Product Change Notice (PCN)

PCN Number: PCN-0450007R-01

Product(s) Affected:
SJ-43504-SMT-TR

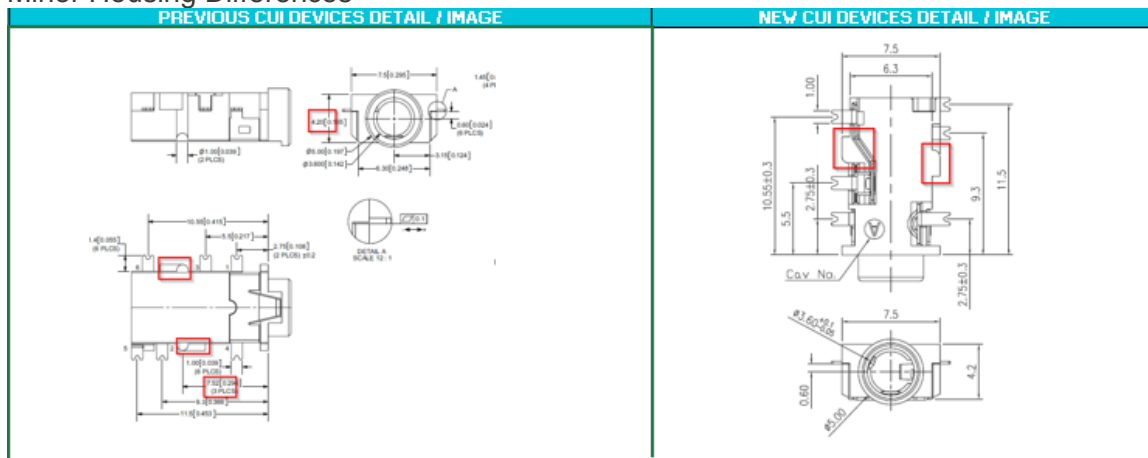
3. Housing and Terminal material Differs

PREVIOUS CUI DEVICES DETAIL / IMAGE	NEW CUI DEVICES DETAIL / IMAGE																																																
<table border="1"> <thead> <tr> <th></th> <th>MATERIAL</th> <th>PLATING</th> </tr> </thead> <tbody> <tr> <td>terminal 1</td> <td>copper alloy</td> <td>gold flash</td> </tr> <tr> <td>terminal 2</td> <td>copper alloy</td> <td>gold flash</td> </tr> <tr> <td>terminal 3</td> <td>copper alloy</td> <td>gold flash</td> </tr> <tr> <td>terminal 4</td> <td>copper alloy</td> <td>gold flash</td> </tr> <tr> <td>terminal 5</td> <td>copper alloy</td> <td>gold flash</td> </tr> <tr> <td>terminal 6</td> <td>copper alloy</td> <td>gold flash</td> </tr> <tr> <td>plastic</td> <td>PA6T or equivalent</td> <td></td> </tr> </tbody> </table>		MATERIAL	PLATING	terminal 1	copper alloy	gold flash	terminal 2	copper alloy	gold flash	terminal 3	copper alloy	gold flash	terminal 4	copper alloy	gold flash	terminal 5	copper alloy	gold flash	terminal 6	copper alloy	gold flash	plastic	PA6T or equivalent		<table border="1"> <thead> <tr> <th>DESCRIPTION</th> <th>MATERIAL</th> <th>PLATING/COLOR</th> </tr> </thead> <tbody> <tr> <td>terminal 1</td> <td>C5210 t=0.20</td> <td>gold flash over nickel</td> </tr> <tr> <td>terminal 2</td> <td>C5210 t=0.20</td> <td>gold flash over nickel</td> </tr> <tr> <td>terminal 3</td> <td>C5210 t=0.20</td> <td>gold flash over nickel</td> </tr> <tr> <td>terminal 4</td> <td>C5210 t=0.20</td> <td>gold flash over nickel</td> </tr> <tr> <td>terminal 5</td> <td>C2680-EH t=0.20</td> <td>gold flash over nickel</td> </tr> <tr> <td>terminal 6</td> <td>C2680-EH t=0.20</td> <td>gold flash over nickel</td> </tr> <tr> <td>housing</td> <td>PA9T [UL94V-0]</td> <td>black</td> </tr> </tbody> </table>	DESCRIPTION	MATERIAL	PLATING/COLOR	terminal 1	C5210 t=0.20	gold flash over nickel	terminal 2	C5210 t=0.20	gold flash over nickel	terminal 3	C5210 t=0.20	gold flash over nickel	terminal 4	C5210 t=0.20	gold flash over nickel	terminal 5	C2680-EH t=0.20	gold flash over nickel	terminal 6	C2680-EH t=0.20	gold flash over nickel	housing	PA9T [UL94V-0]	black

MATERIAL	PLATING																																															
terminal 1	copper alloy	gold flash																																															
terminal 2	copper alloy	gold flash																																															
terminal 3	copper alloy	gold flash																																															
terminal 4	copper alloy	gold flash																																															
terminal 5	copper alloy	gold flash																																															
terminal 6	copper alloy	gold flash																																															
plastic	PA6T or equivalent																																																
DESCRIPTION	MATERIAL	PLATING/COLOR																																															
terminal 1	C5210 t=0.20	gold flash over nickel																																															
terminal 2	C5210 t=0.20	gold flash over nickel																																															
terminal 3	C5210 t=0.20	gold flash over nickel

terminal 4	C5210 t=0.20	gold flash over nickel																																															
terminal 5	C2680-EH t=0.20	gold flash over nickel																																															
terminal 6	C2680-EH t=0.20	gold flash over nickel																																															
housing	PA9T [UL94V-0]	black

1. Minor Housing Differences

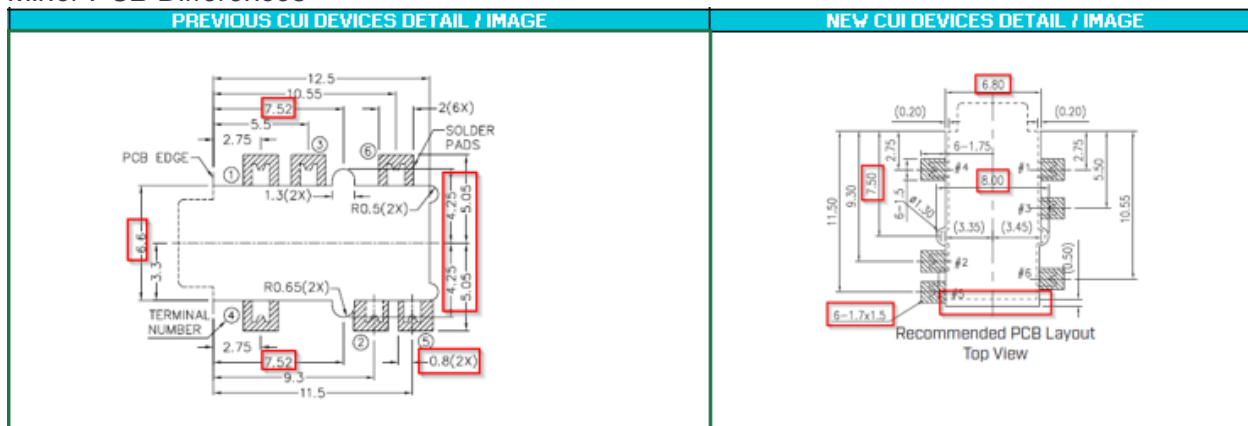
2. Minor PCB Differences
